ADDENDUM

PROJECT: Forestside Estates
Attmar & Palleschi Drive
Brampton, Ontario

ADDENDUM NO. E-2

PURPOSE: To suit architecture, sprinkler system changes and Mech Addendum M-4.

TITLE		PARKING LEVEL PART A ELECTRICAL	
PROJECT		BRAMPTON STACKED FORESTSIDE ESTATES	
DRAWN		CHECKED	SCALE
SP	MG		1:100
DATE		PROJECT	DRAWING
MAY, 2019		18-017	E-2A
			OF 16

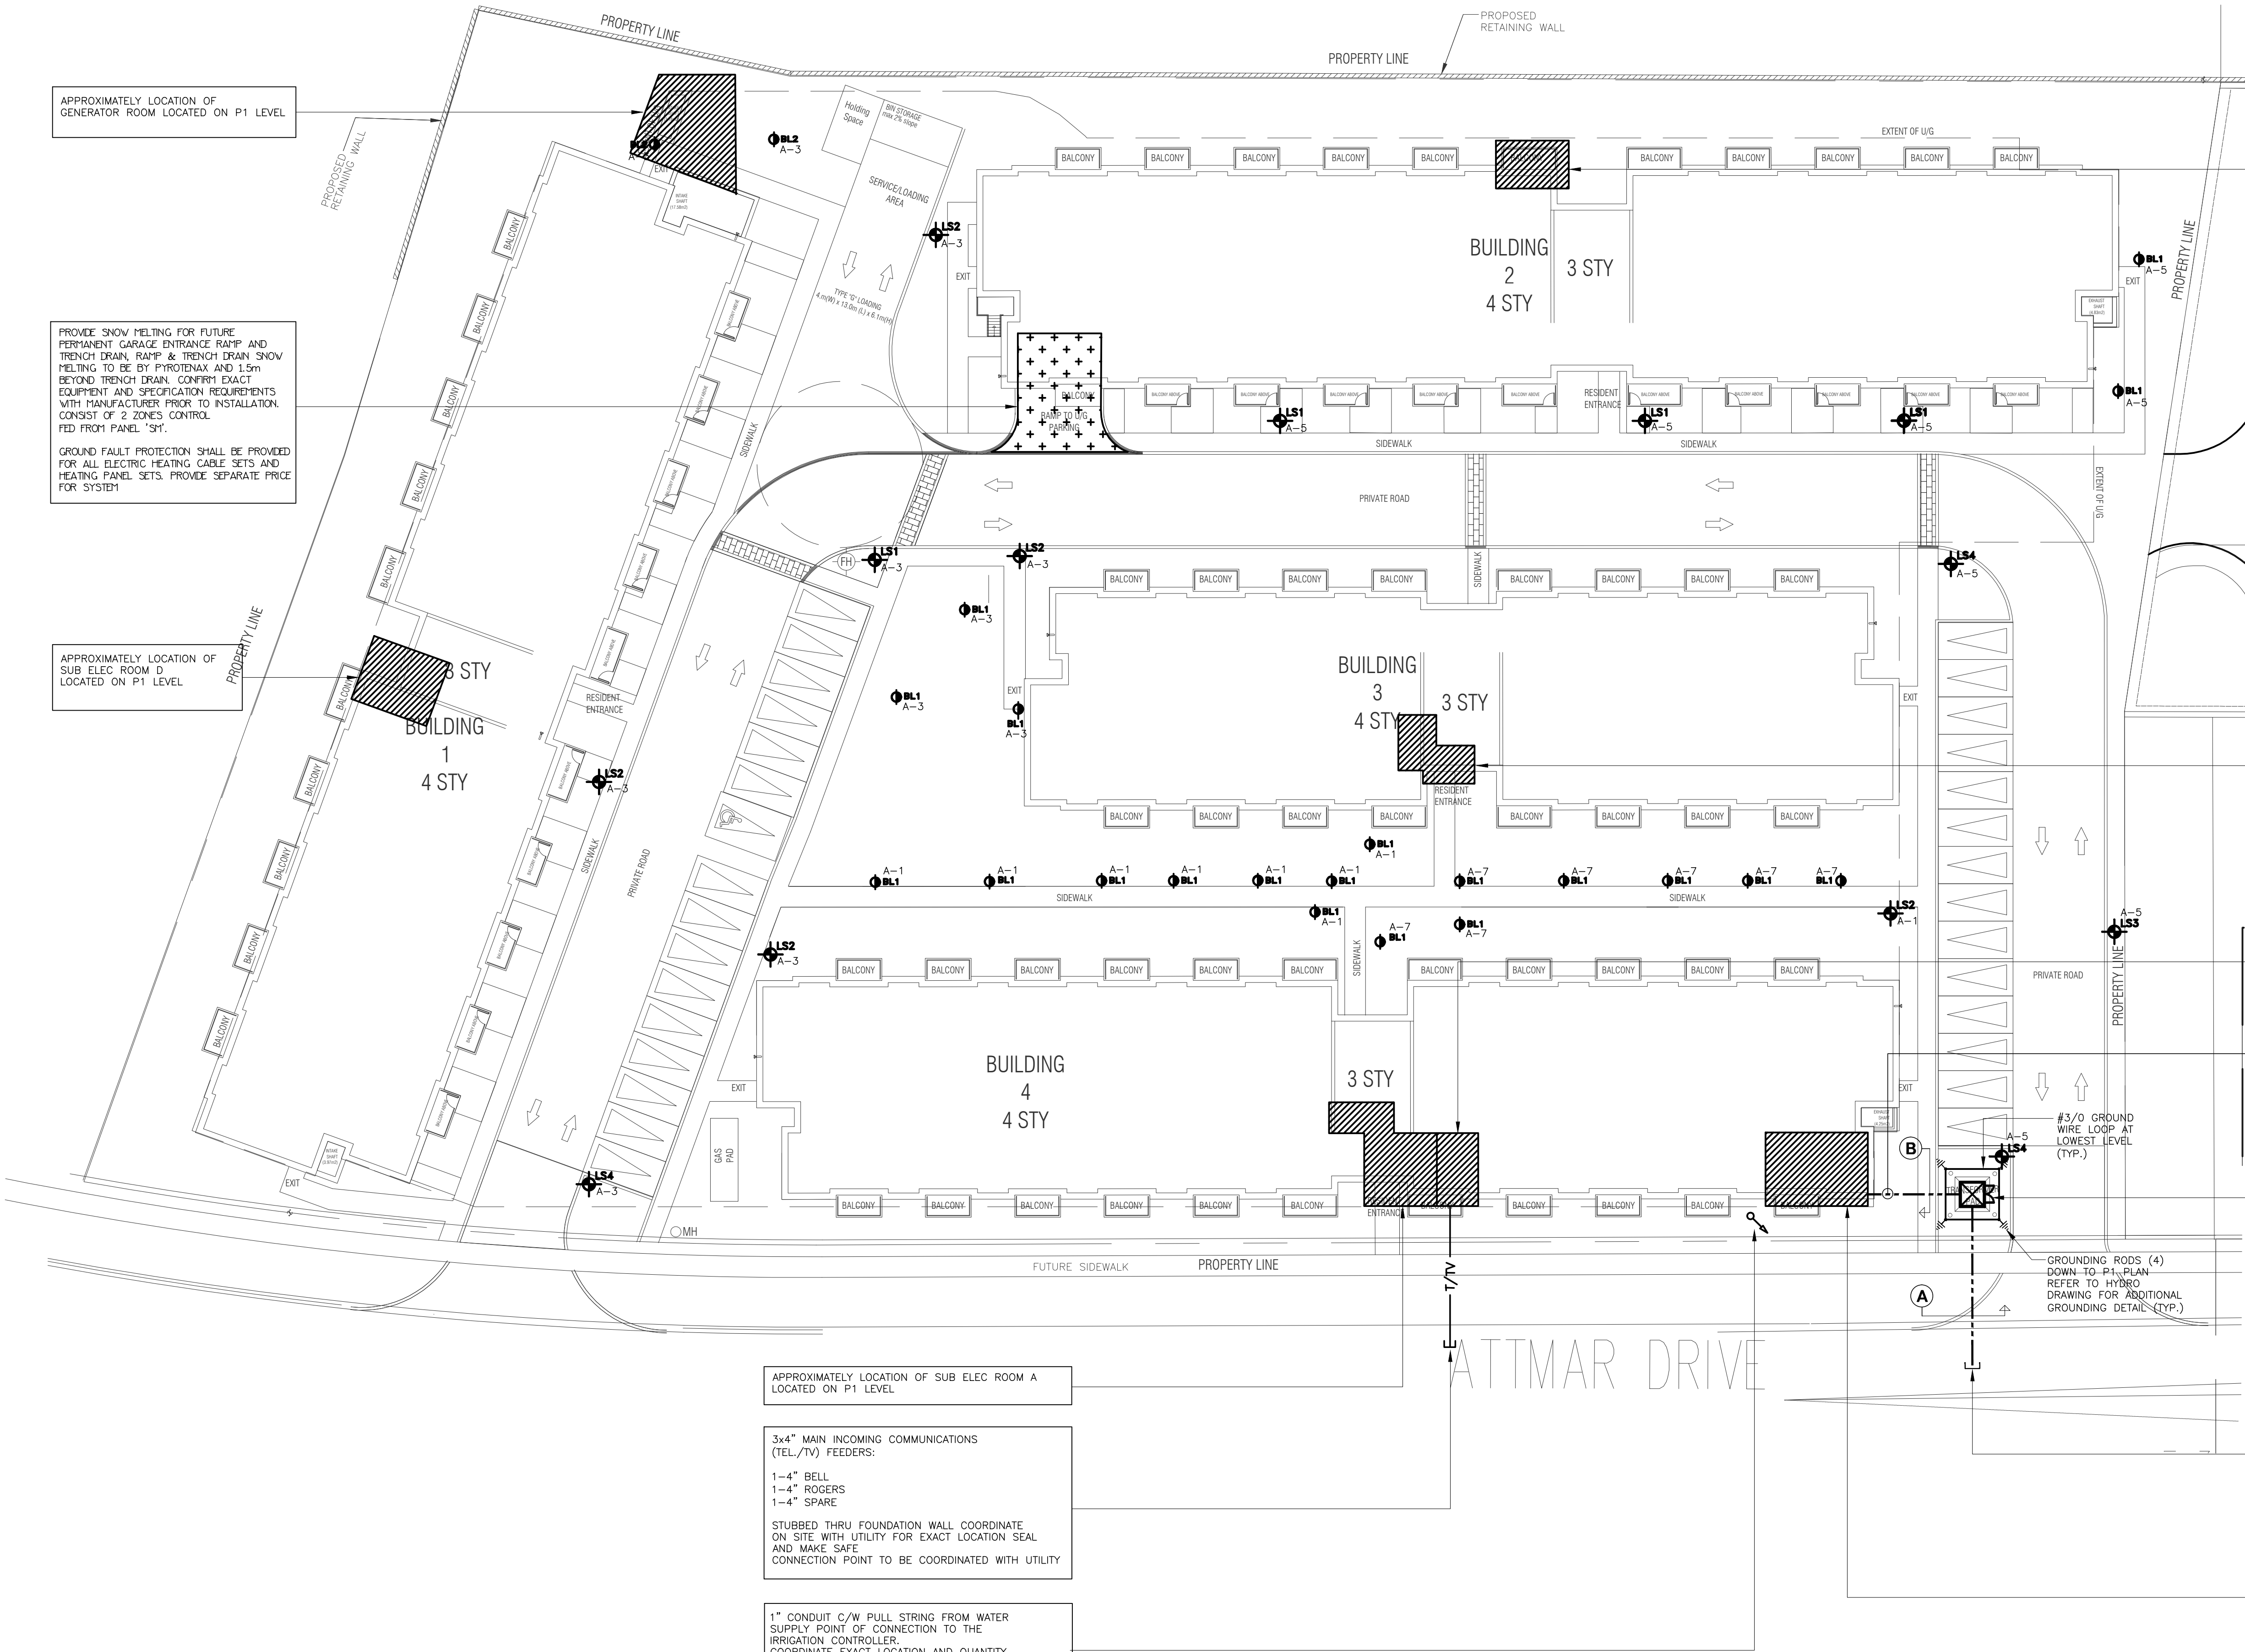
2.1 Revise: Electrical layout to suit latest arch drawings as shown.

TITLE
**2ND FLOOR PLAN
ELECTRICAL**

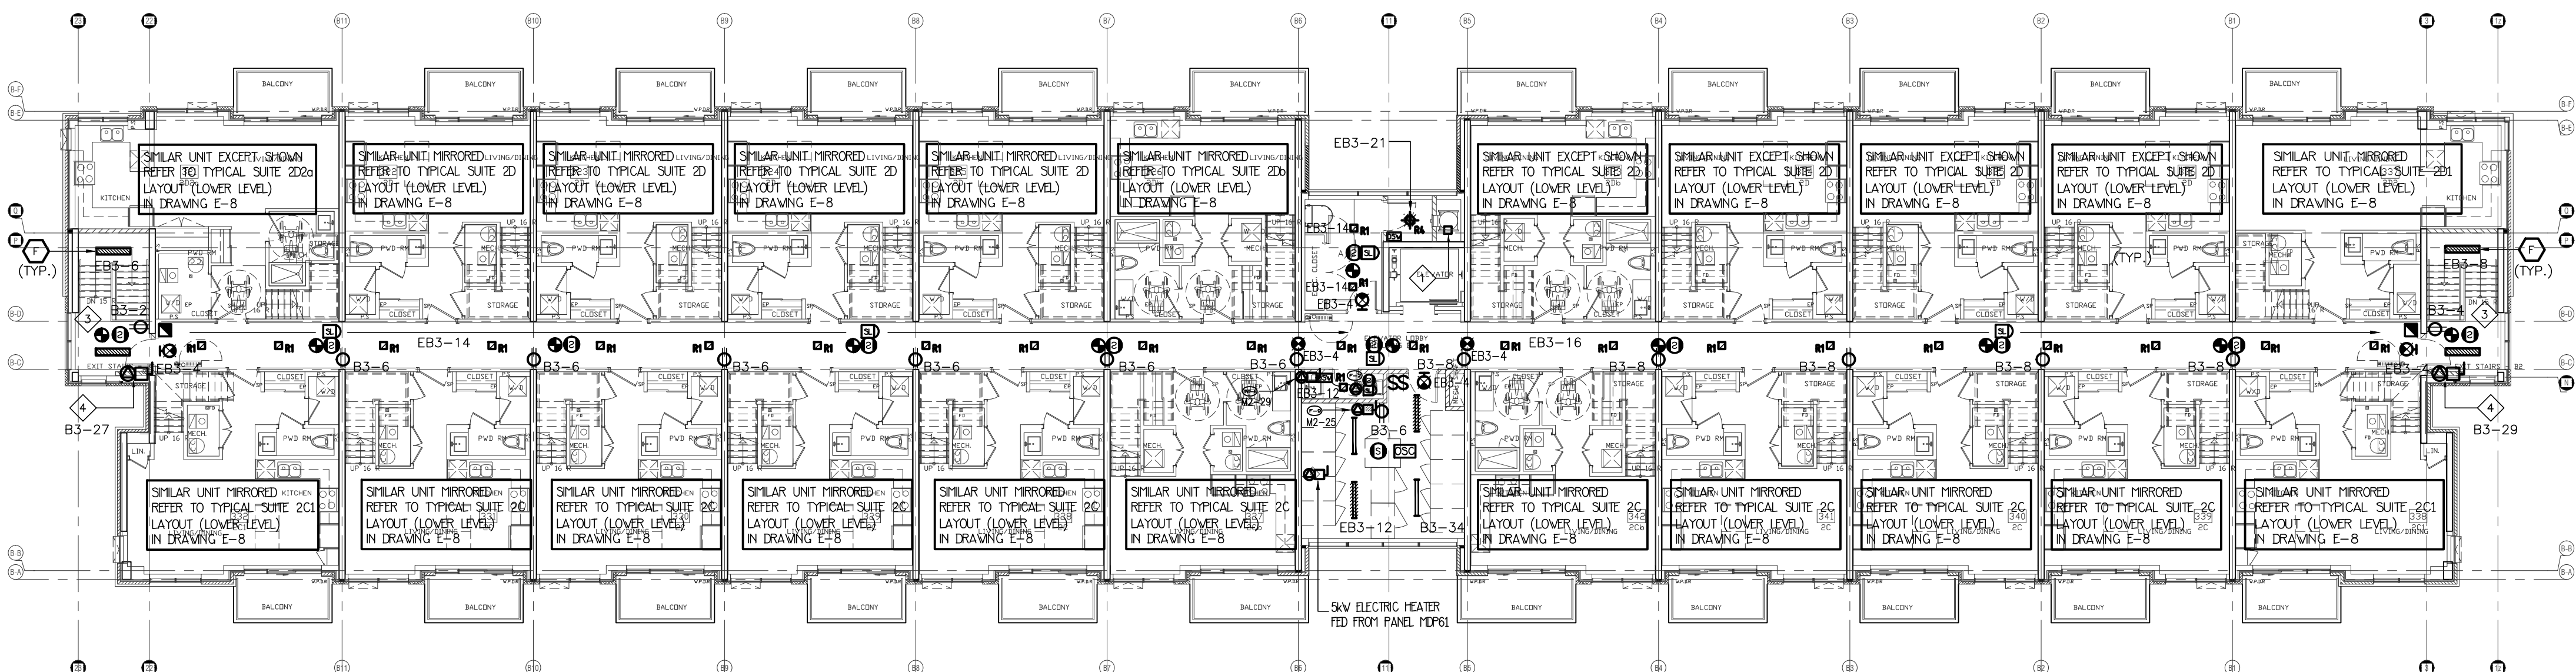
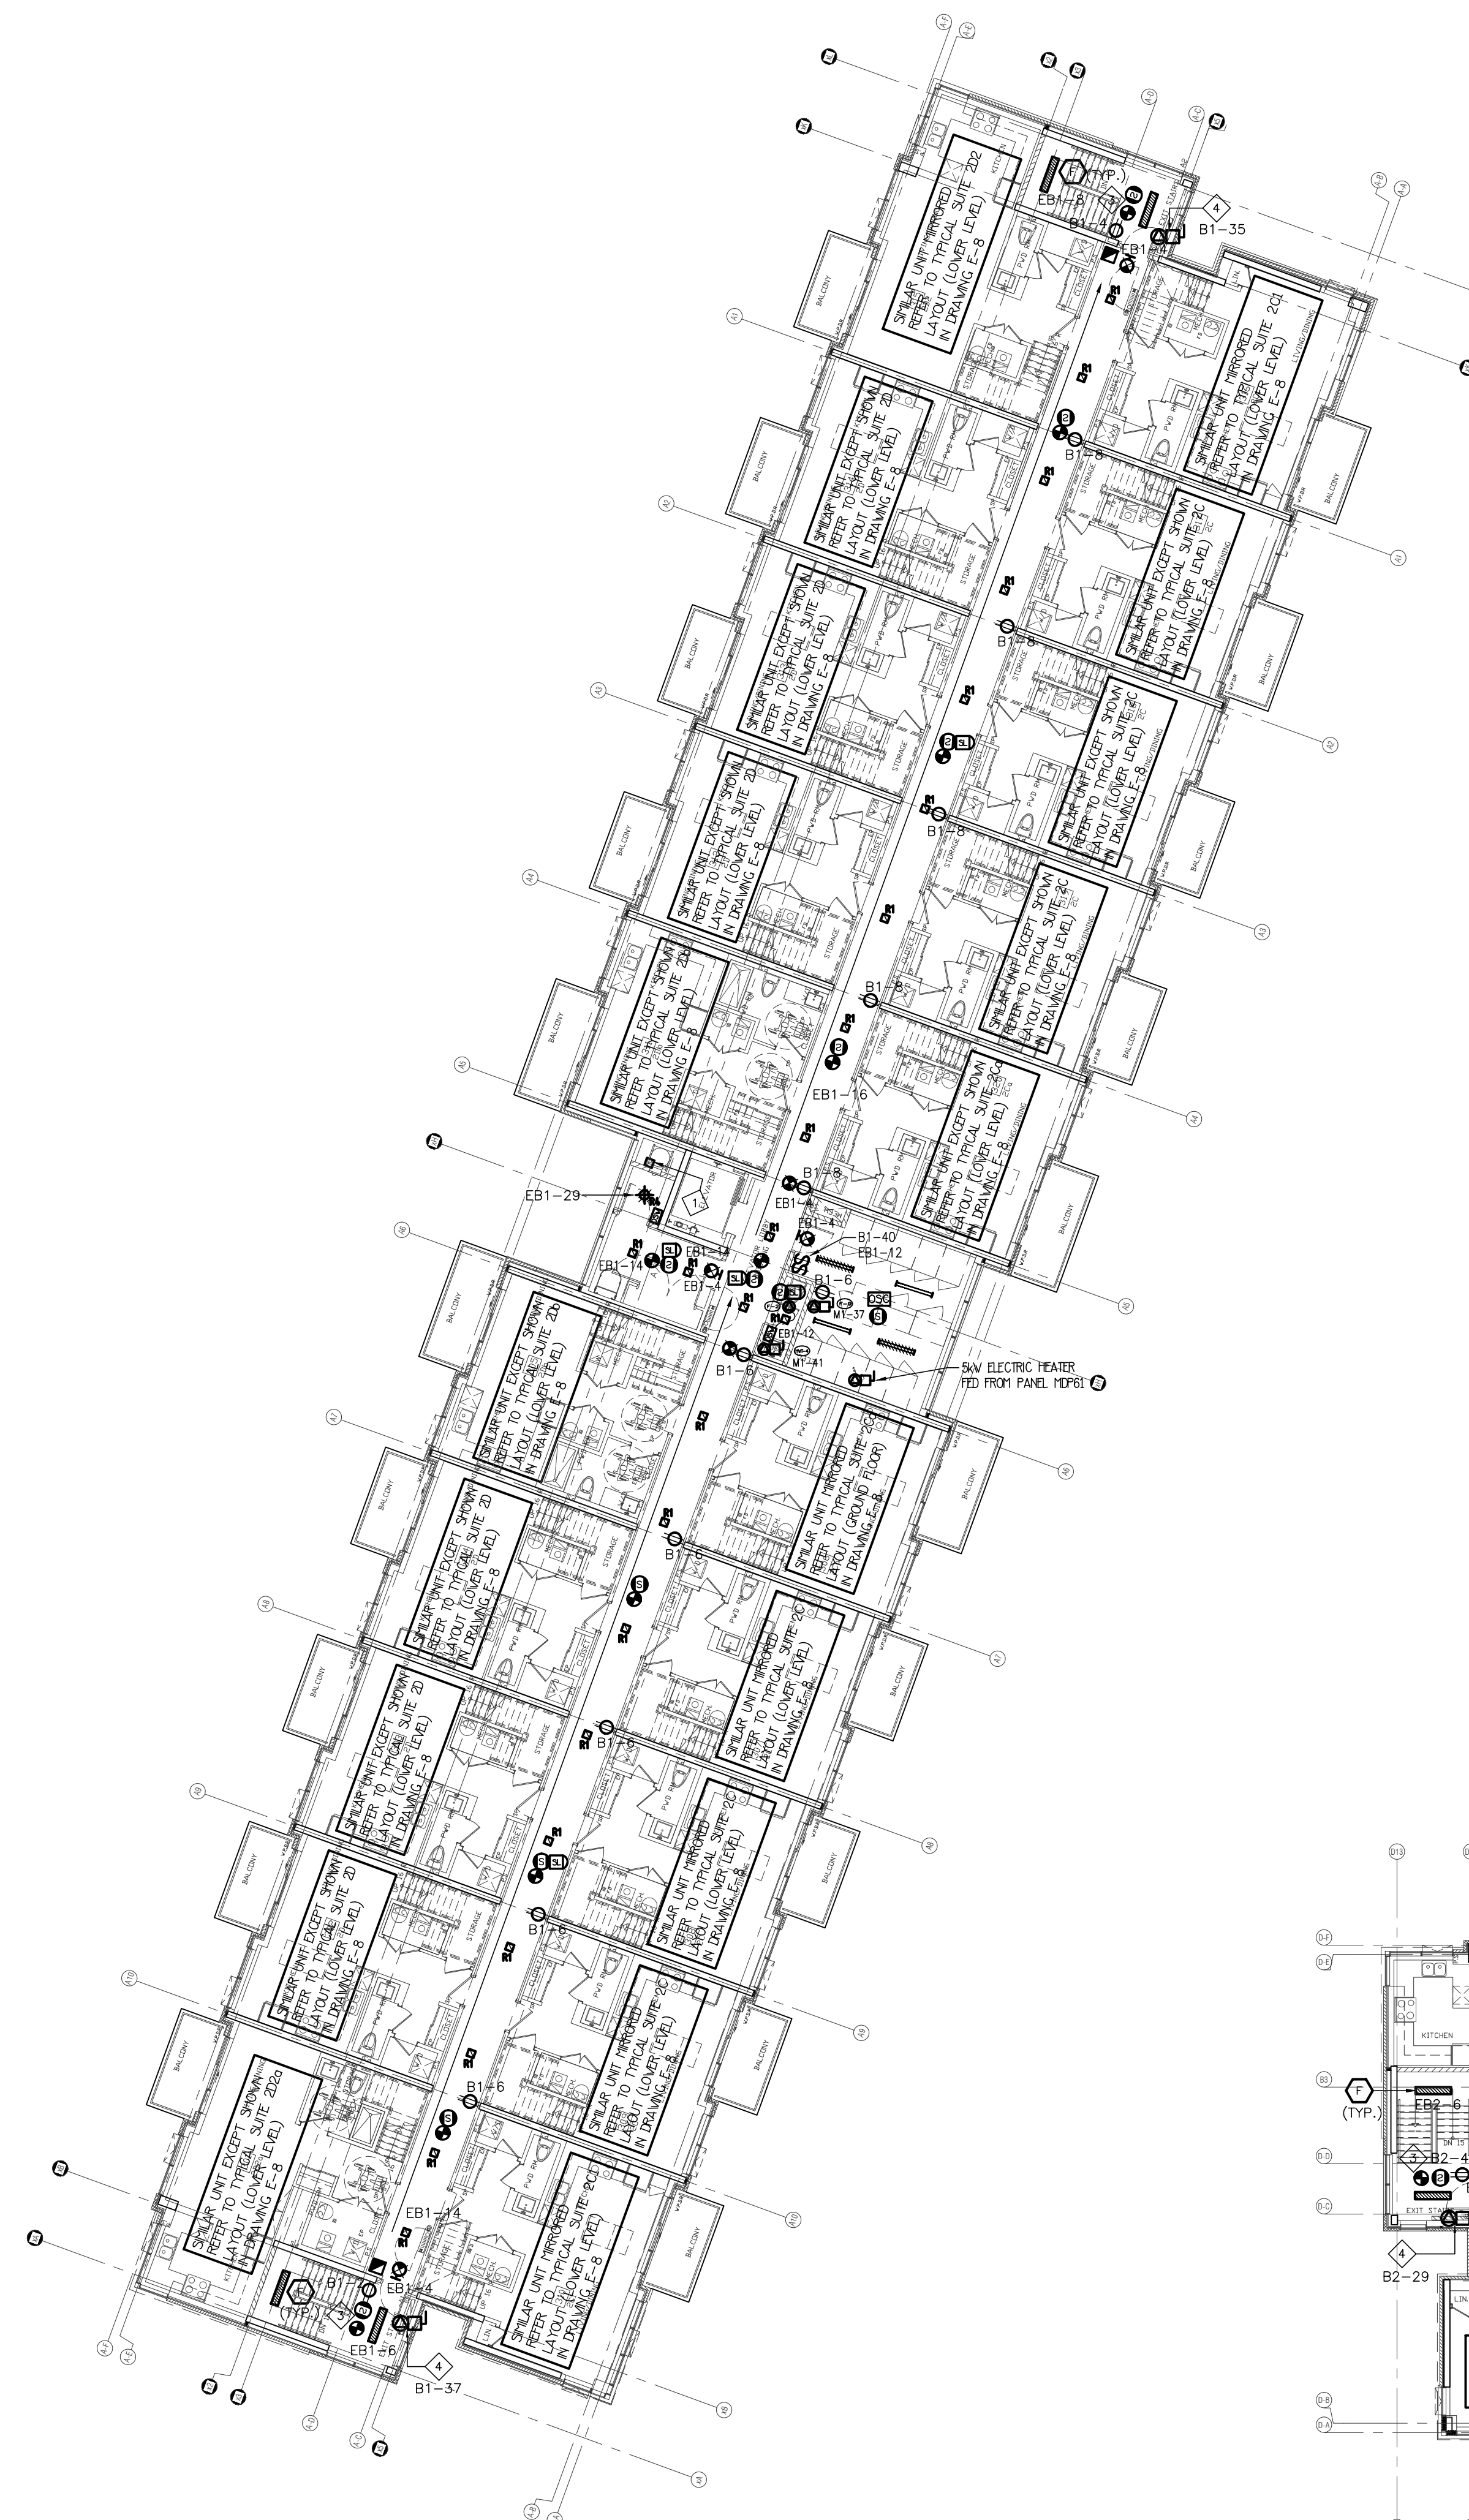
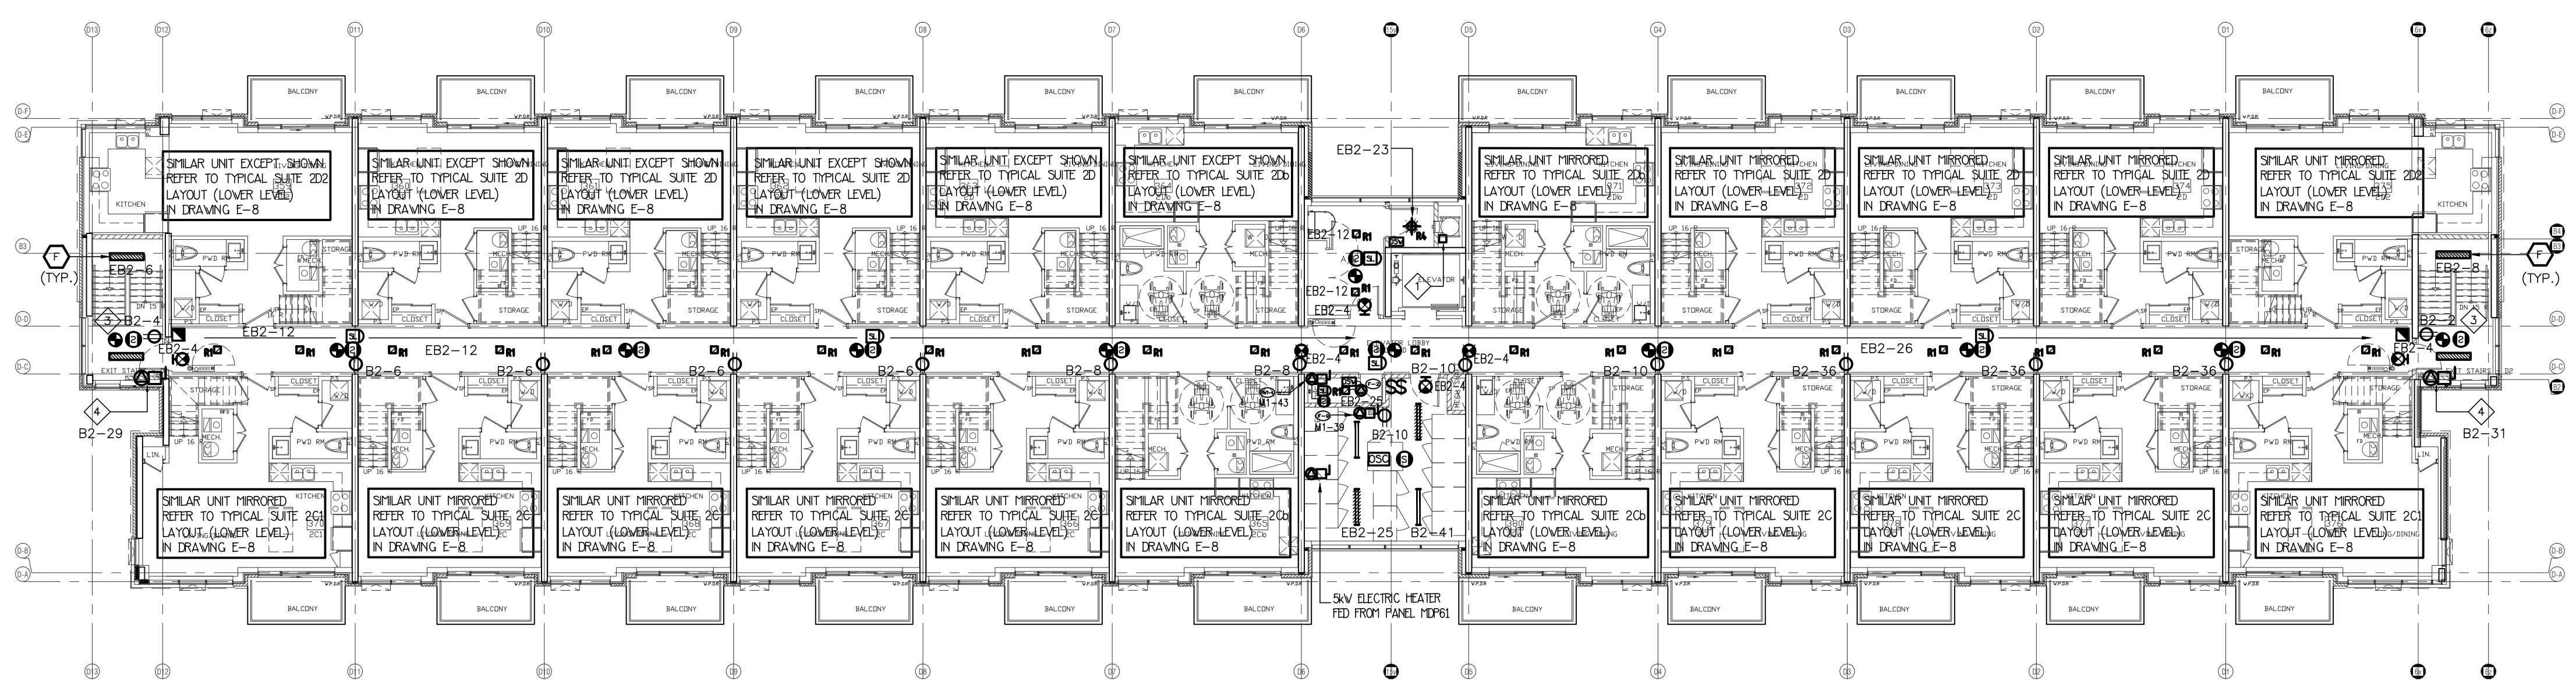
3.1 Revise: Electrical layout to suit latest arch drawings as shown
